APPROVED MINUTES

February 16, 2023 Standards Committee Meeting

TO: Standards Committee

RE: Minutes from the February 16, 2023 Standards Committee Meeting

E 809-ITCS-01 ITS TRAFFIC COUNT STATIONS INDEX AND GENERAL NOTES (revised draft)

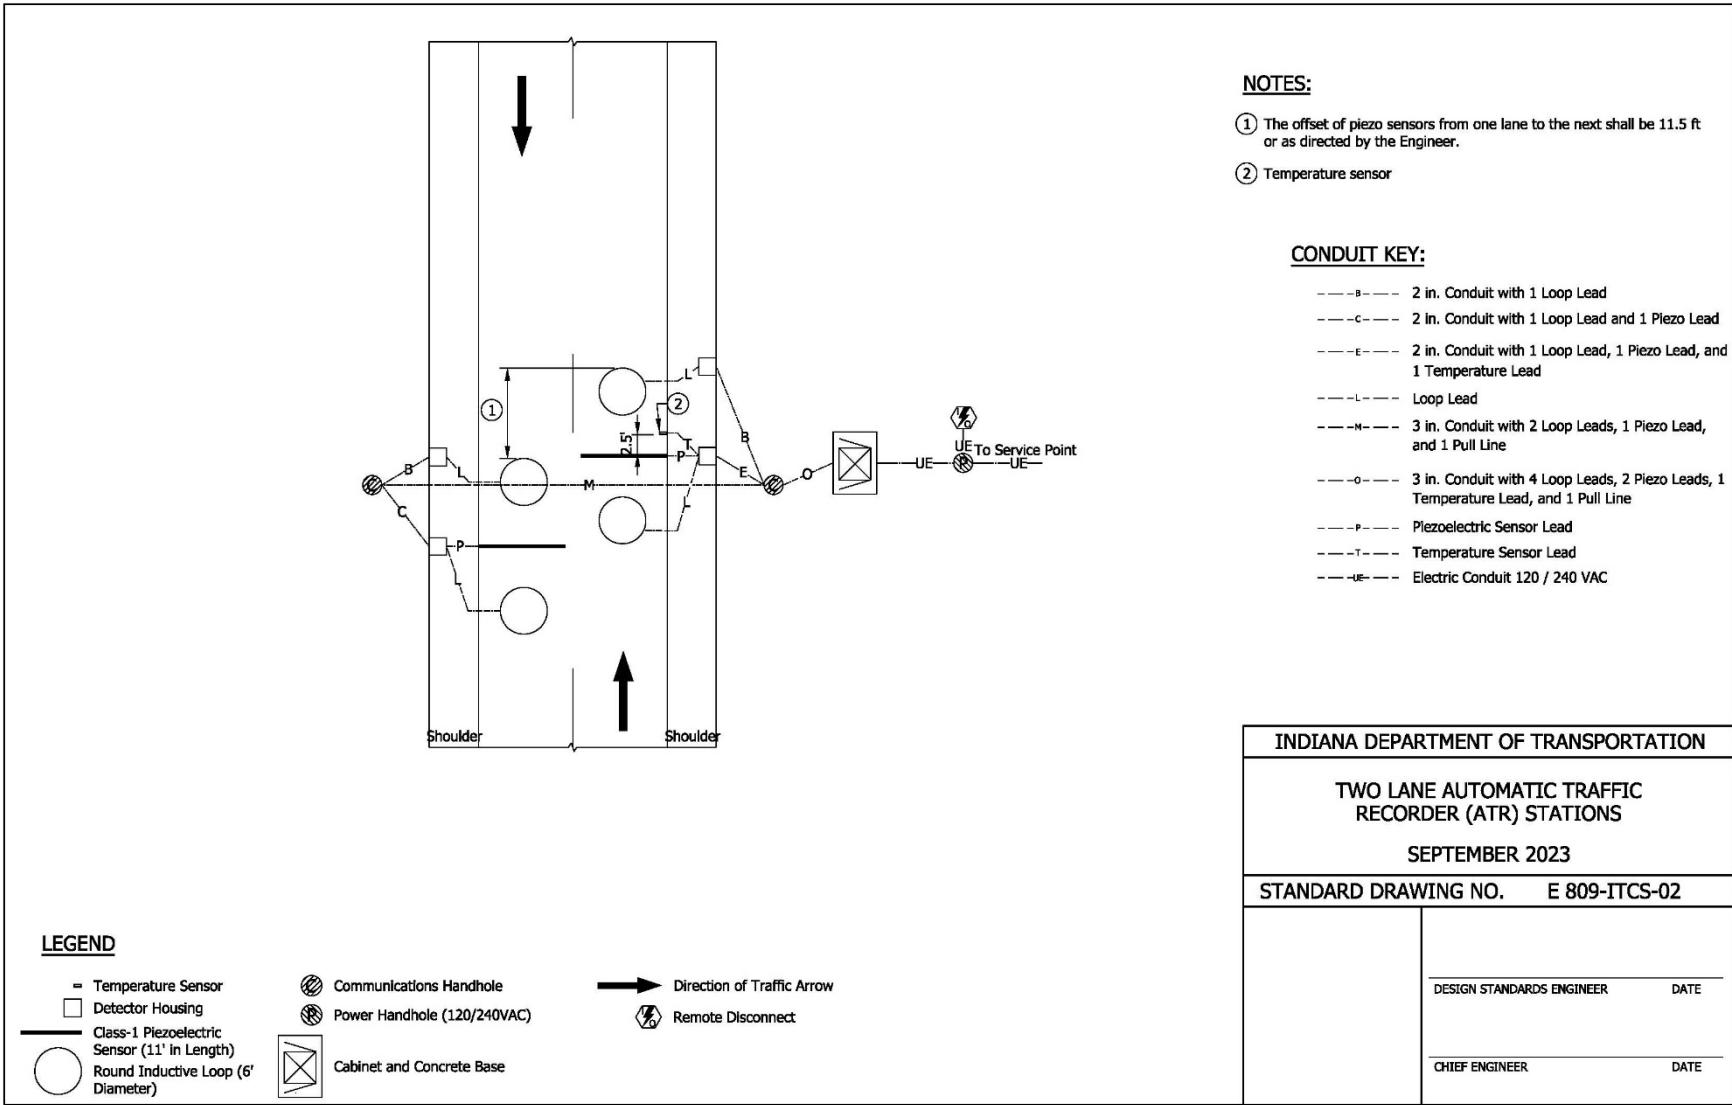
Mr. Koch stated, concerning drawing 809-ITCS-01: Referencing ASTM E 1318 is good design guidance, yet most will not read second level specifications. Horizontal & longitudinal alignment constraints should be addressed by the Designer. Also, what is the smoothness criteria for note #2? Please consider RSP 401-R-577.

Mr. Sorenson responded that we agree that the site selection criteria and geometric criteria of E1318 should be addressed by the designer, and we will make sure language similar to 401-R-577 is included in future contracts involving WIM sites to make clear to contractors our expectations. The smoothness criteria in note 2 was meant to be a general rule to assist designers in rough site selection (since it will be very difficult to meet E1318 specs at pavement transitions, for example), but if the E1318 spec is met so too will the criteria in note 2, so we will remove that note.

E 604-SWCR-11 MEDIAN CUT-THROUGH AND MEDIAN PERPENDICULAR CURB RAMP TYPICAL PLACEMENT (with shown markups)

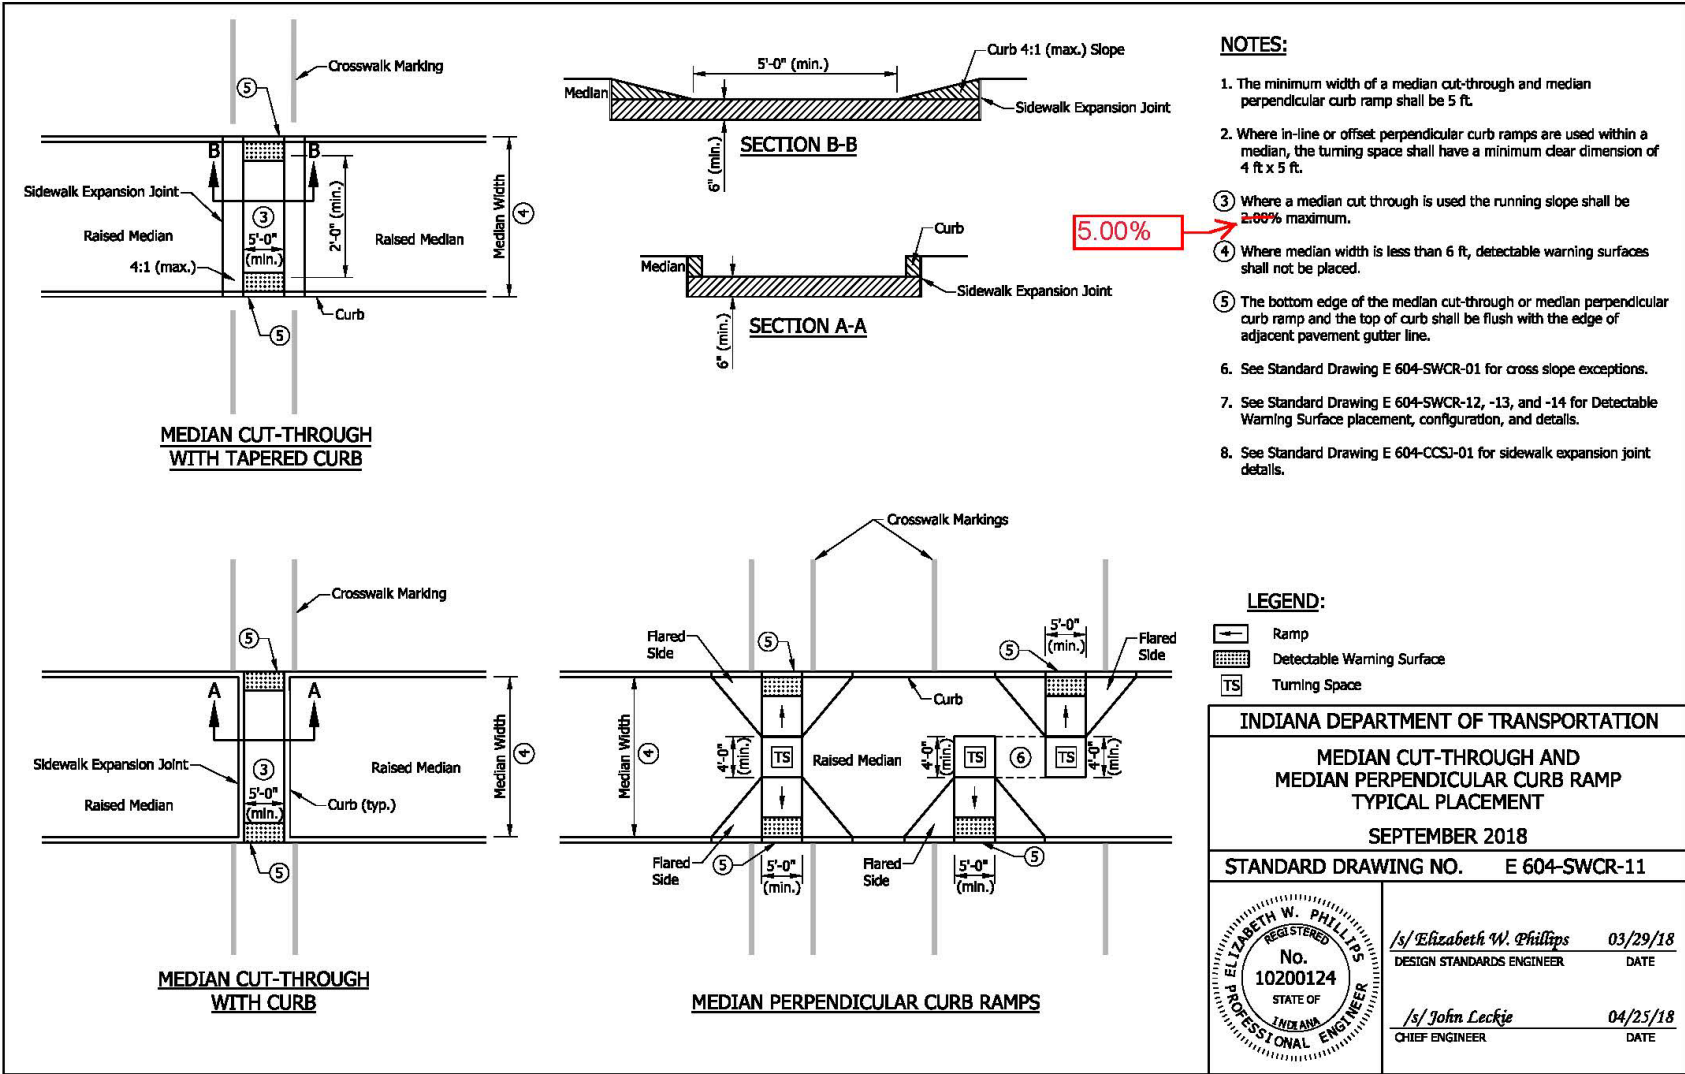
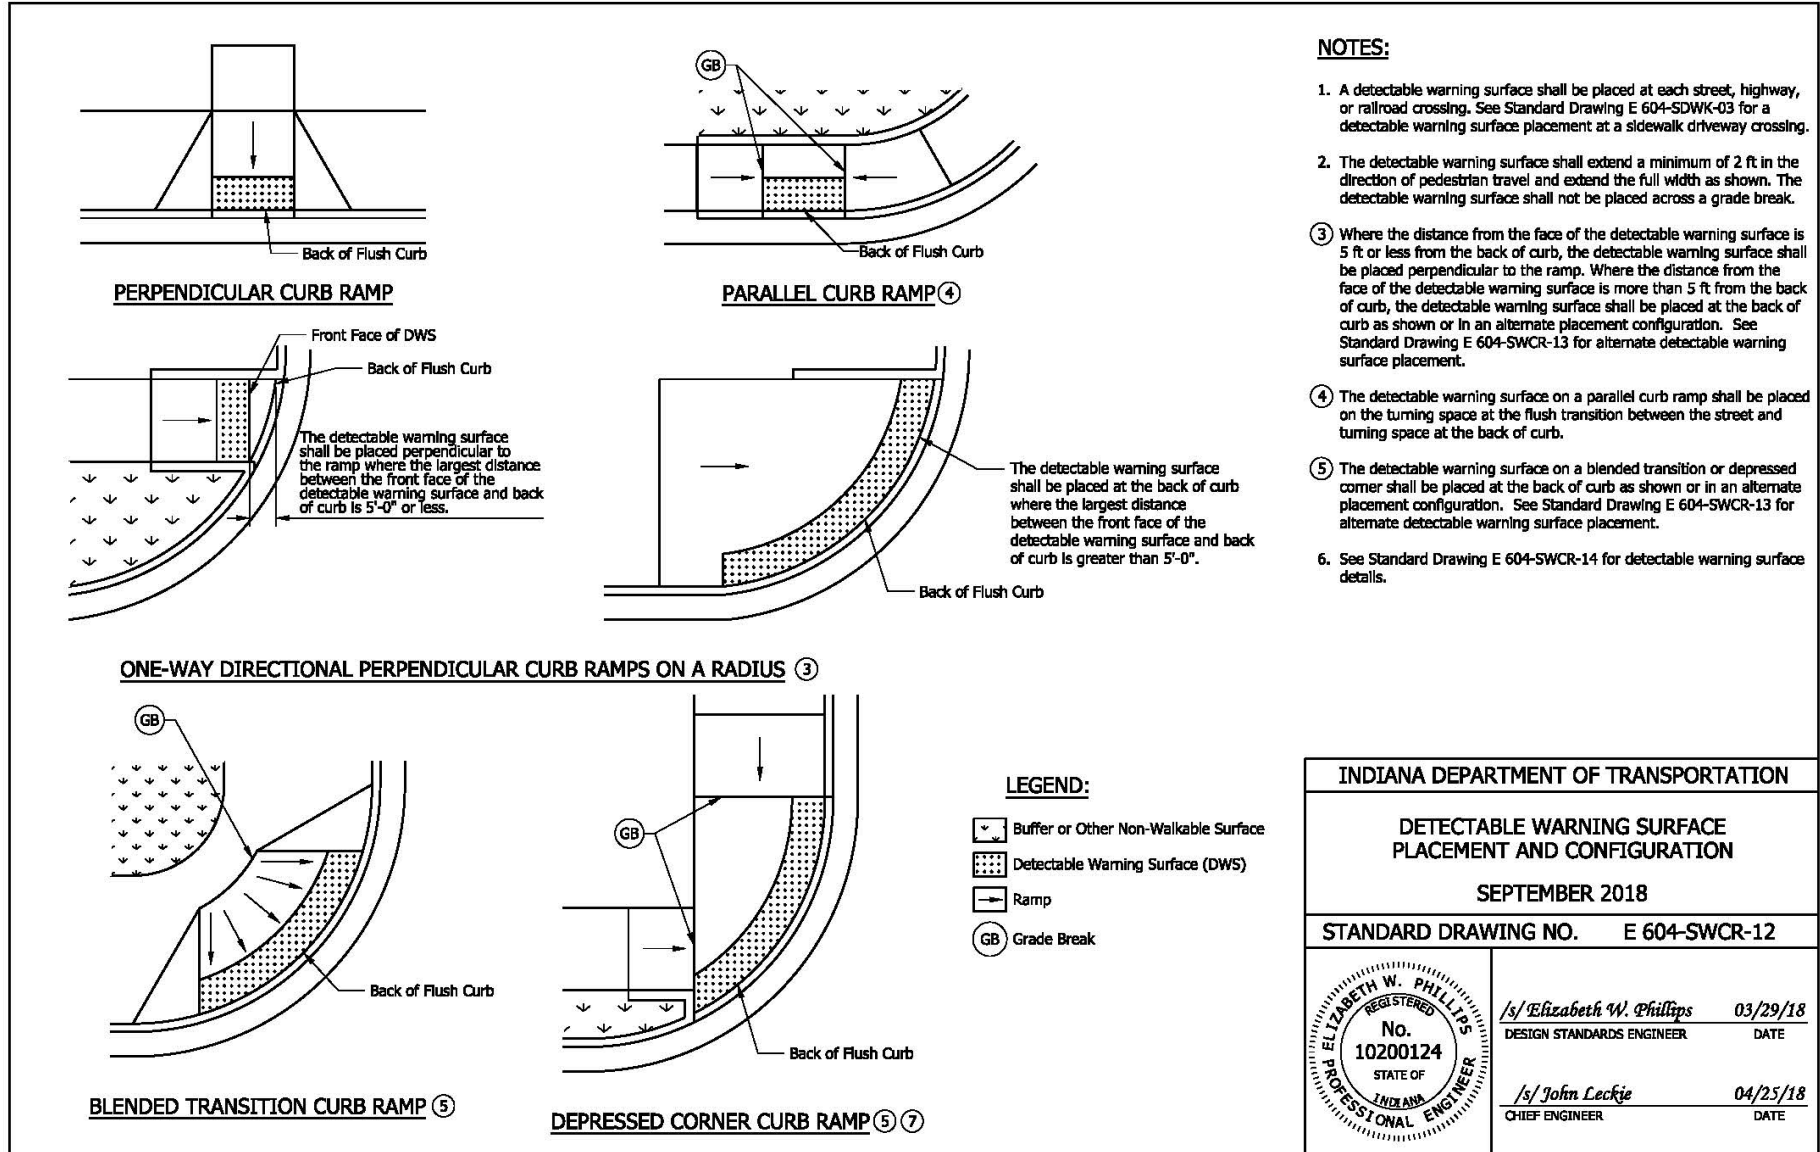
PROBLEM(S) ENCOUNTERED: Standard Drawing series 604-SWCR. Standard Drawing 604-SWCR-11, note 3, limits the running slope of a median cut-through to 2%. Upon further review of the Proposed Right-of-Way Accessibility Guidelines (PROWAG) and clarification from the US Access Board, the running slope may be a maximum of 5%. Given the geometry of divided highways and intersections, the increase of the maximum running slope will allow for more flexibility in design. Standard Drawing 604-SWCR-13, there has been some confusion on the offset of a detectable warning surface from a railroad crossing. The current drawing only takes into account a perpendicular crossing of a sidewalk, where many crossings are at a skew. When a railroad crosses a sidewalk at a skew, the designer and contractor must take into account the minimum and maximums within the Public Rights-of-Way Accessibility Guidelines (PROWAG) and the location of the railroad dynamic envelope.

Mr. Orton proposed to change note 3 in Standard Drawing 604-SWCR-11, to state where a median cut-through is used, the running slope shall be 5.00% maximum. And in Standard Drawing 604-SWCR-13, add a skewed railroad crossing detail, add dynamic envelope lines to both railroad crossing details, modify note 4 to define the dynamic envelope location, and add a note to give the minimum and maximum offset of a detectable warning surface in relationship to the dynamic envelope and the nearest rail.

PROPOSED SOLUTION: Standard Drawing 604-SWCR-11, change note 3 to state, where a median cut-through is used the running slope shall be 5.00% maximum. Standard Drawing 604-SWCR-13, add a skewed railroad crossing detail, add dynamic envelope lines to both railroad crossing details, modify note 4 to define the dynamic envelope location, and add a note to give the minimum and maximum offset of a detectable warning surface in relationship to the dynamic envelope and the nearest rail.
